Rezoning Transportation Analysis

Petition Number: 2019-085

Revision Log:	Date	Description
	07-17-2019	First Review

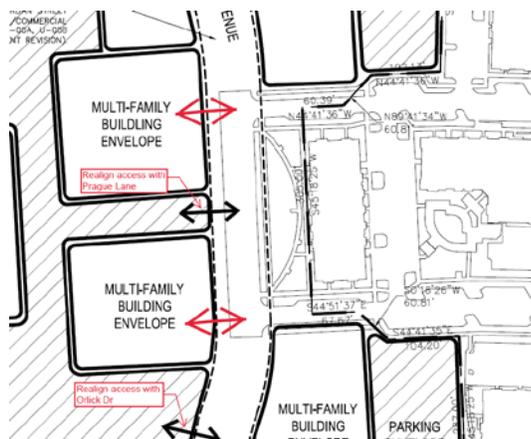
- The petitioner should revise the site plan and conditional note(s) to acquire formal agreements with the property owner of parcel ID 20145115 to establish cross access easements for street connections to existing Prague Lane and Orlick Drive.
- The petitioner should revise the site plan and the conditional notes by adding the notes shown below from the approved 2008-053 rezoning plan in reference to the Arrowood-Whitehall Connector road.

Constructing a roadway bridge to accommodate pedestrians and bikes over I-485.

Completion of the functional design of the grade-separated connection from the development site over I-485 to Whitehall Park Drive. The purpose of the functional design is to establish the horizontal and vertical alignments of the proposed connection. Structural design of the bridge sufficient to determine substructure and superstructure thickness, profile grades, slopes/cut-and-fill limits, and right-of-way shall occur prior to the issuance of a final certificate of occupancy for the first building in Phase Ic, and such plans shall be submitted by the petitioner as part of the subdivision process. The petitioner shall confer with CDOT, NCDOT, and FHWA as necessary to determine whether steel, reinforced concrete, or another material shall be used for the substructure prior to developing the functional design plans. The bridge shall be designed to accommodate the following:

- A. Two 11-foot travel lanes and a left-turn lane as needed for access to parking decks/lots
- B. Two 5-foot bike lanes
- C. Two 8-foot sidewalks
- D. Curb and gutter
- E. Bridge rails

In connection with the preparation of the functional design of the grade-separated connection from the development site over I-485 to Whitehall Park Drive, the petitioner shall determine the location and width of the right of way on the western side of I-485 on tax parcel no. 201-021-28 to be dedicated to the City of Charlotte (the "City") for the grade separated connection as provided in paragraph 4 below.

Construct the approach (which will be paved) for the future grade separated connection over I-485 from the development site's internal spine road to the driveways into the parking structures to be located on the development site adjacent to I-485. From that point south/west, construct an earthen slope to be tied in prior to the control of access line. The petitioner will dedicate all necessary right-of-way, easements, and controlled access limits on the development site for the future grade separated connection.

Upon the completion of the functional design of the grade-separated connection from the development site over I-485 to Whitehall Park Drive, the petitioner shall reserve right of way on the western side of I-485 on tax parcel no. 20102128 for the grade separated connection.
